NORTH ANNA COL

**DATA REPORT REV. 0
JANUARY 23, 2007**

**DOCUMENTATION OF TECHNICAL REVIEW
SUBCONTRACTOR WORK PRODUCT**

SUMMARY OF REVISIONS REV. 2 CPT REPORT (table 1 only revised and issued)

Location: CPT-907 1

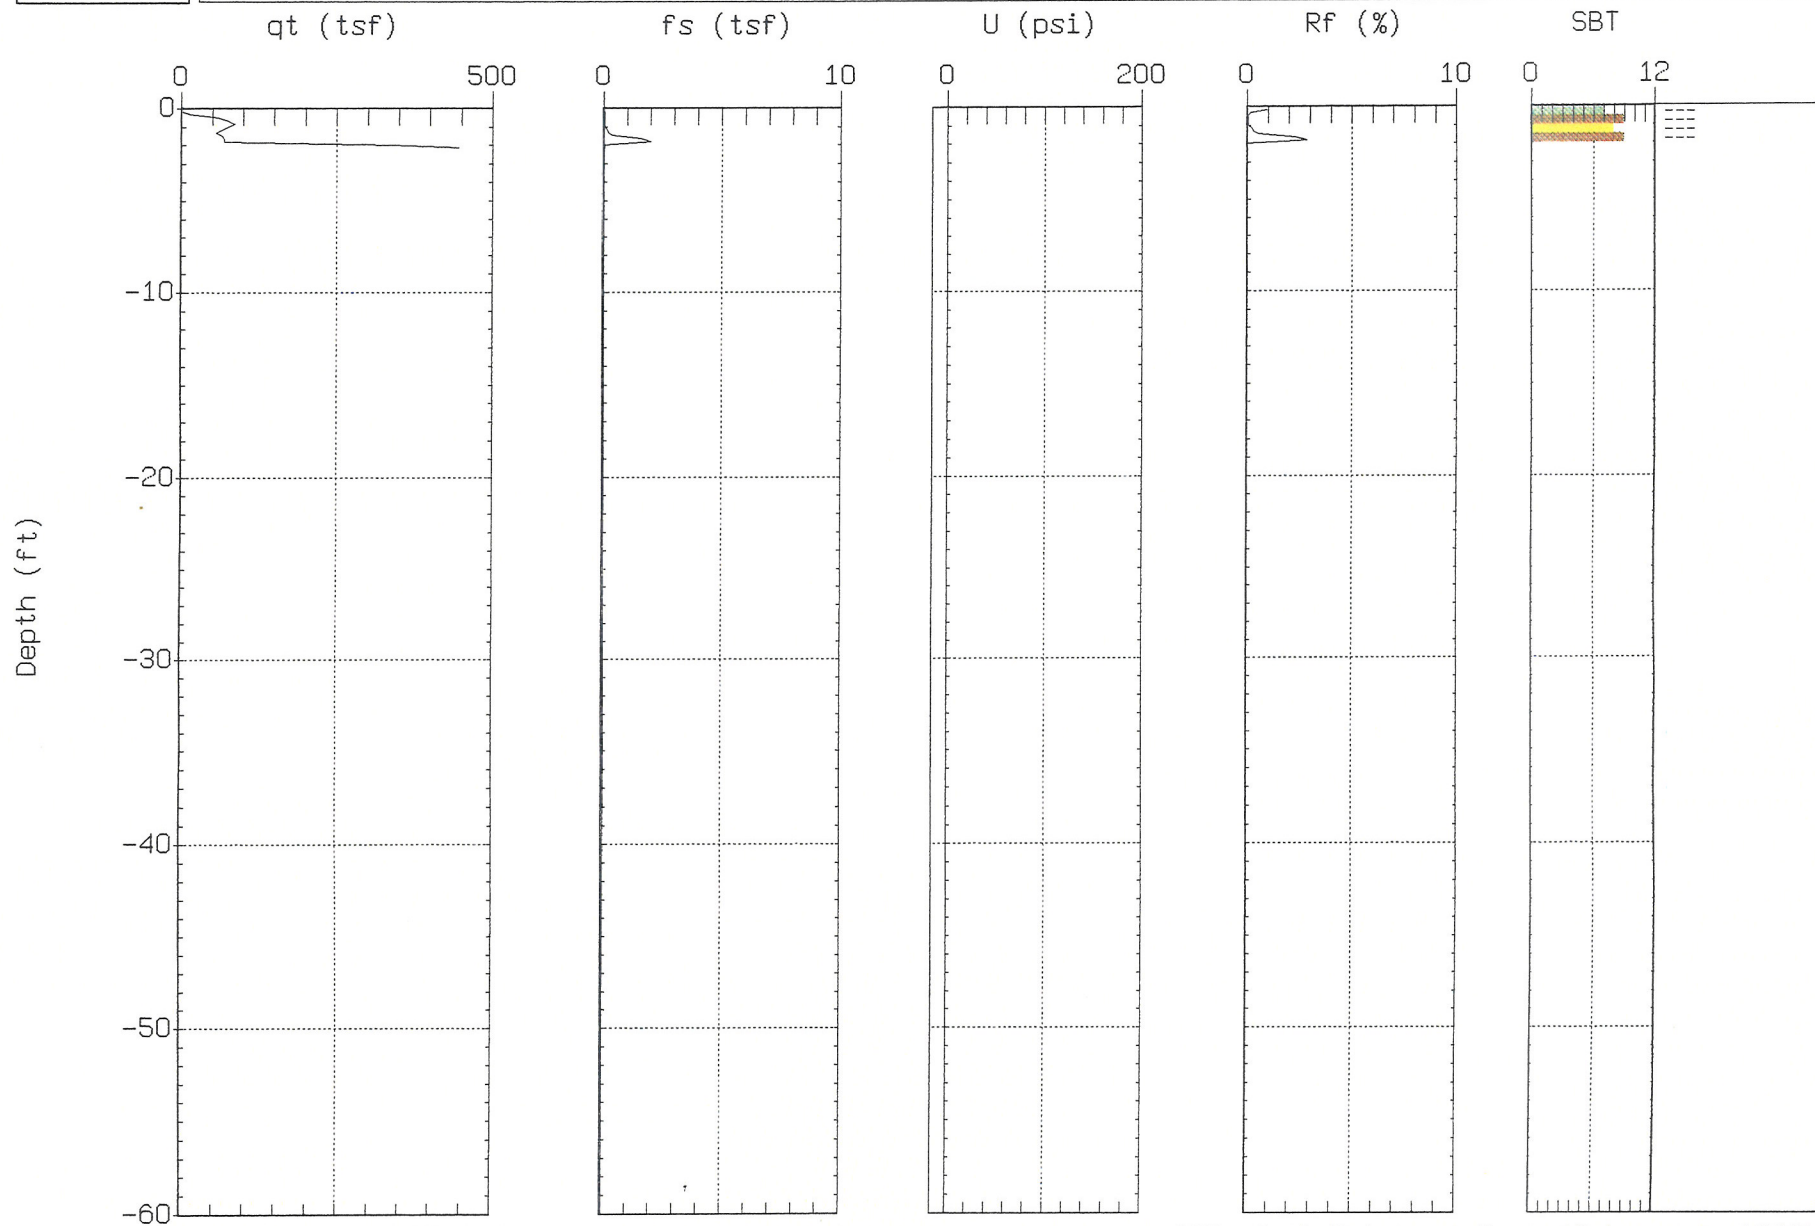
1. Cone Penetration Test Sounding Summary – Table 1. Replaced table to correct mis-numbering of CPT-907 and CPT-917.
2. Plots for correct CPT-907 inserted. No plots for CPT-907 were included in the original report.
3. Replaced plots for CPT-917 with correct plots.
4. Removed plot of Pore Pressure Dissipation Test labeled CPT-907 and replaced with plot correctly labeled CPT-917.
